**TRANSMITTAL OF THE SITE EVALUATION REPORT FOR ADDENDUM 2 SOIL
PILES AT THE PADUCAH GASEOUS DIFFUSION PLANT, PADUCAH, KENTUCKY
(DOE/LX/07-0188&D2/R1)**

Document Identification: *Site Evaluation Report for Addendum 2 Soil Piles at the Paducah Gaseous Diffusion Plant, Paducah, Kentucky, DOE/LX/07-0188&D2/R1*

**Site Evaluation Report
for Addendum 2 Soil Piles
at the Paducah Gaseous Diffusion Plant,
Paducah, Kentucky**

Figure B.8. Location of Sample Stations in Addendum 2 Soil Pile Sampling for Cadmium in the Surface

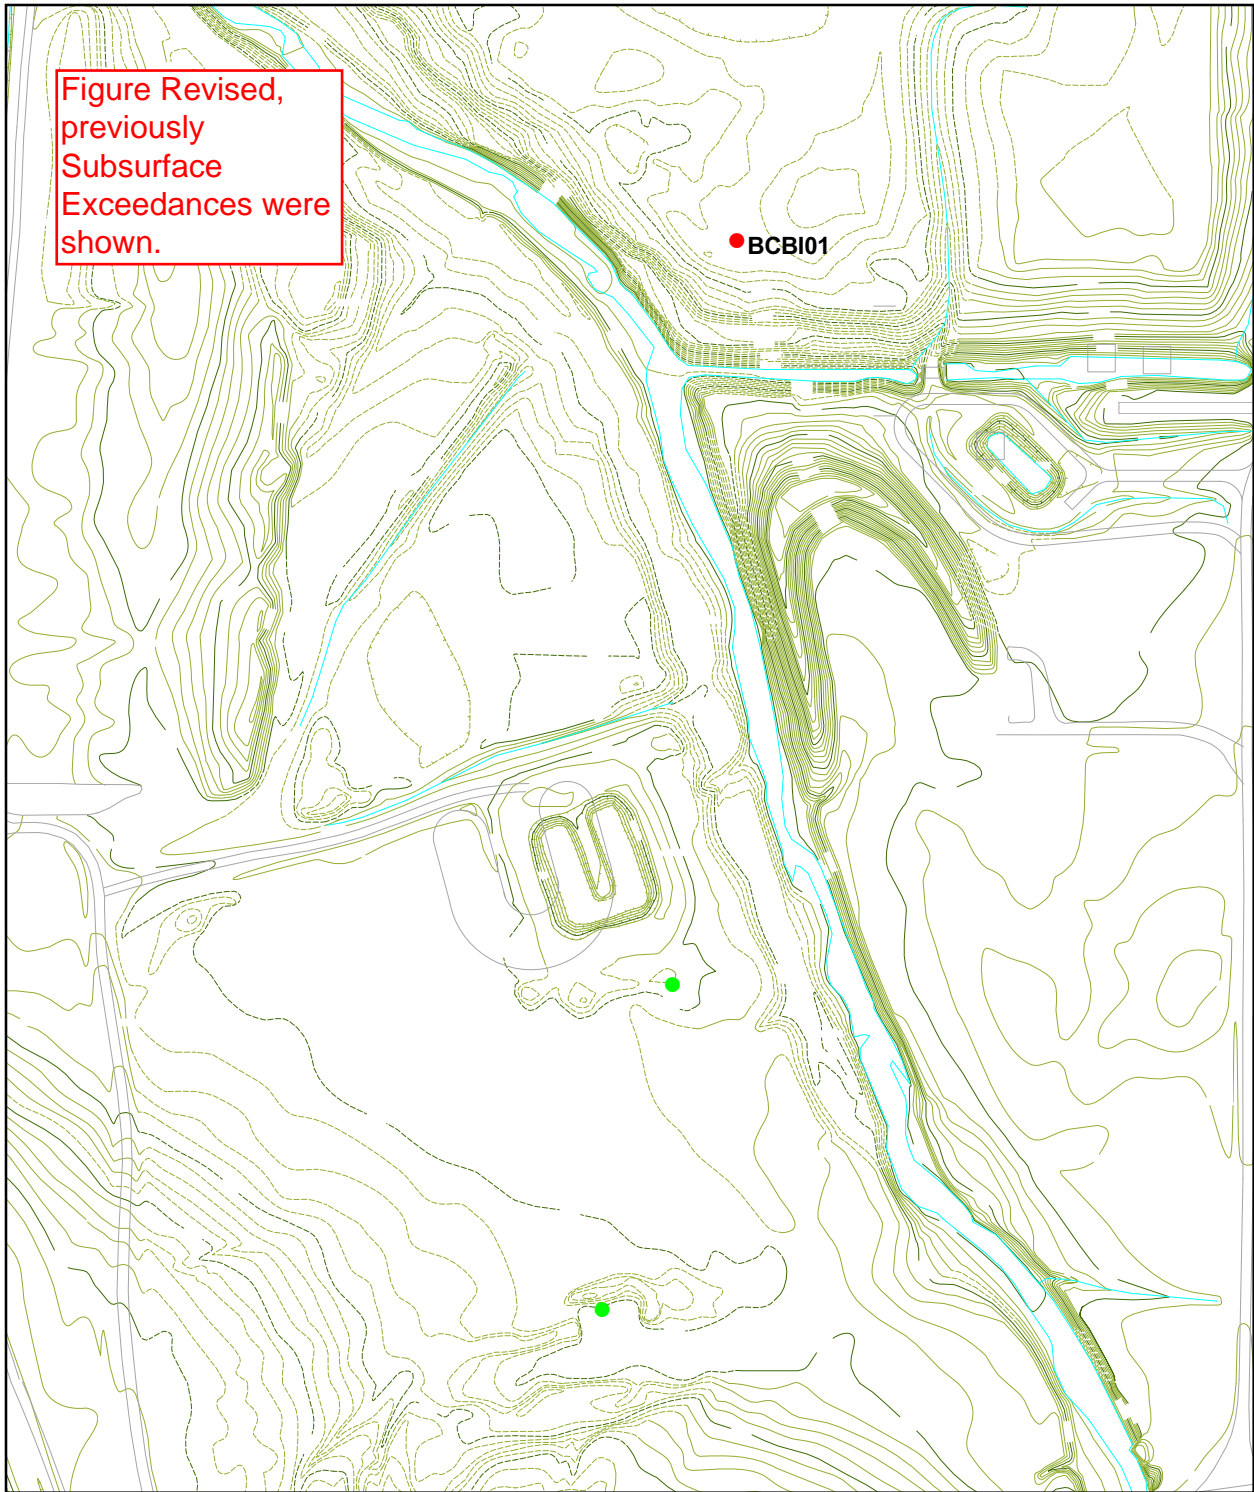
Figure Revised,
previously
Subsurface
Exceedances were
shown.

Figure B.10. Location of Sample Stations in Addendum 2 Soil Pile Sampling for Cadmium in the Subsurface

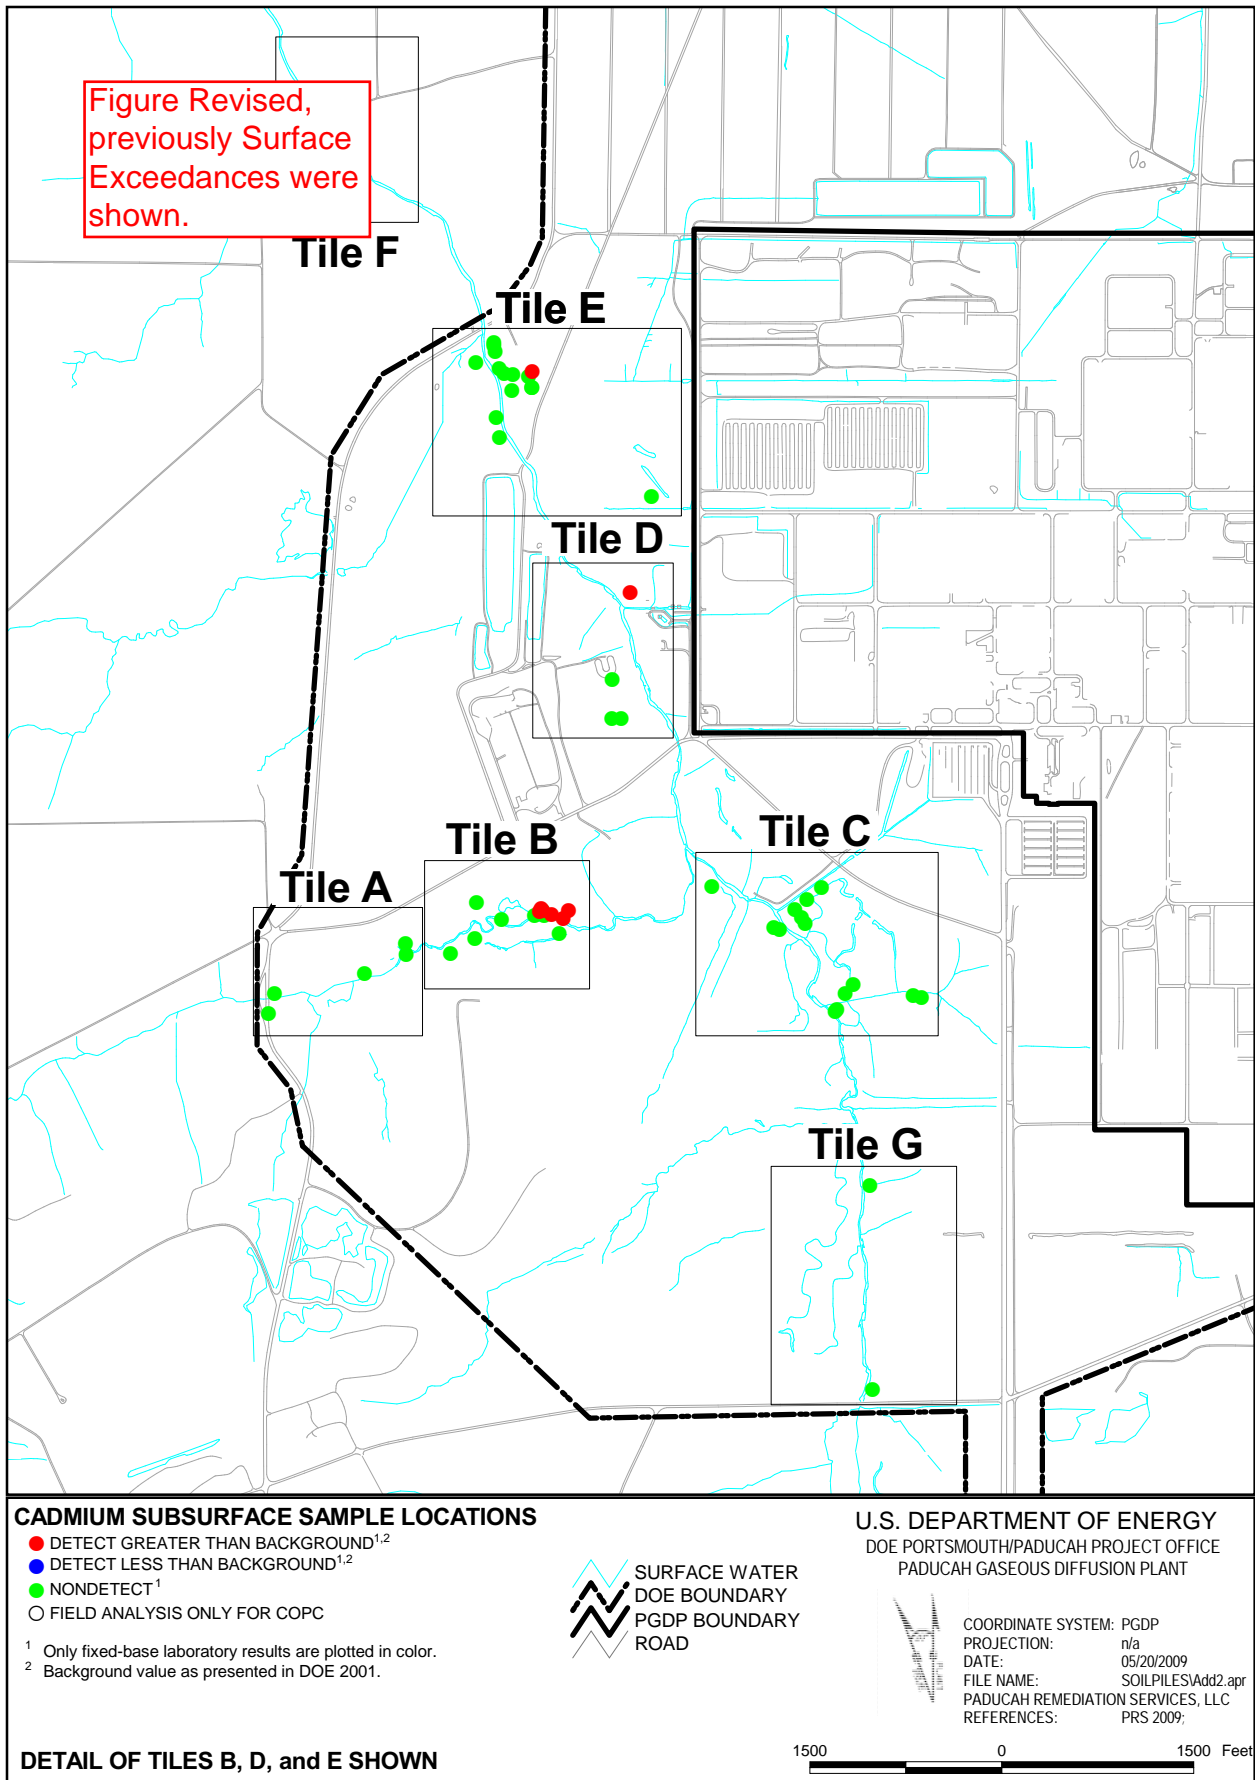
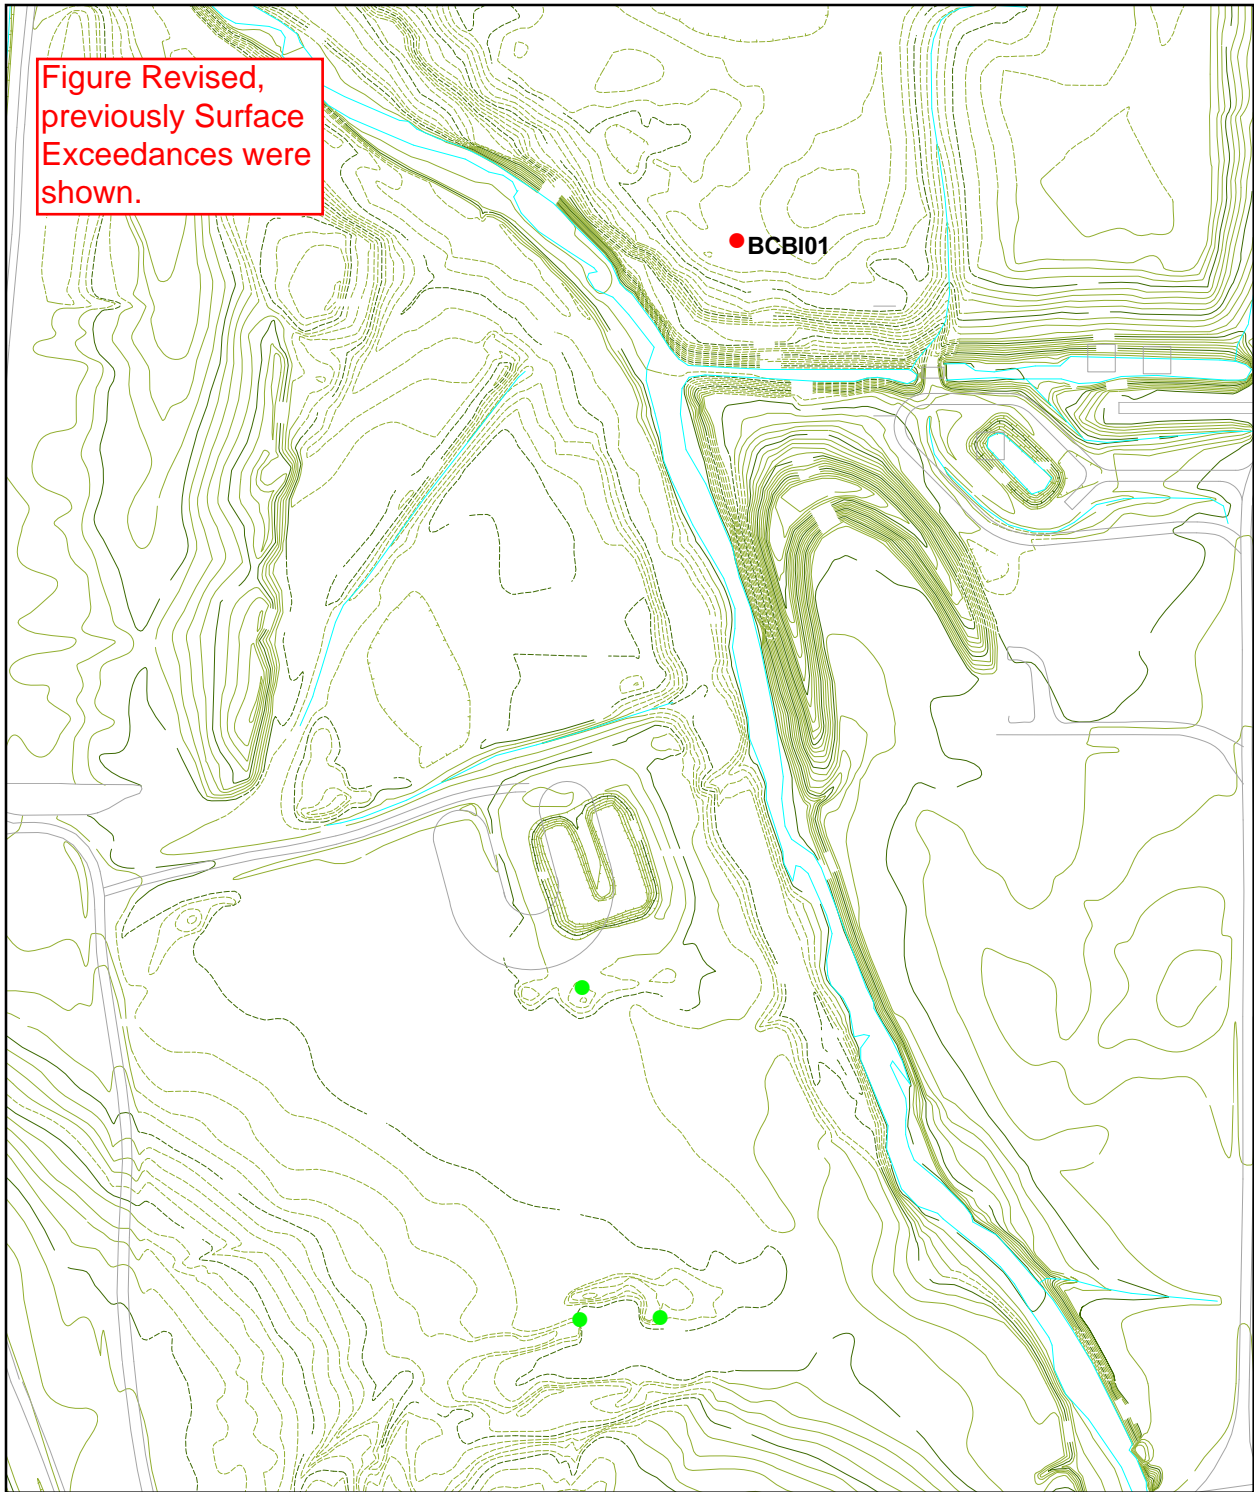
Figure Revised,
previously Surface
Exceedances were
shown.

Figure Revised,
previously Surface
Exceedances were
shown.
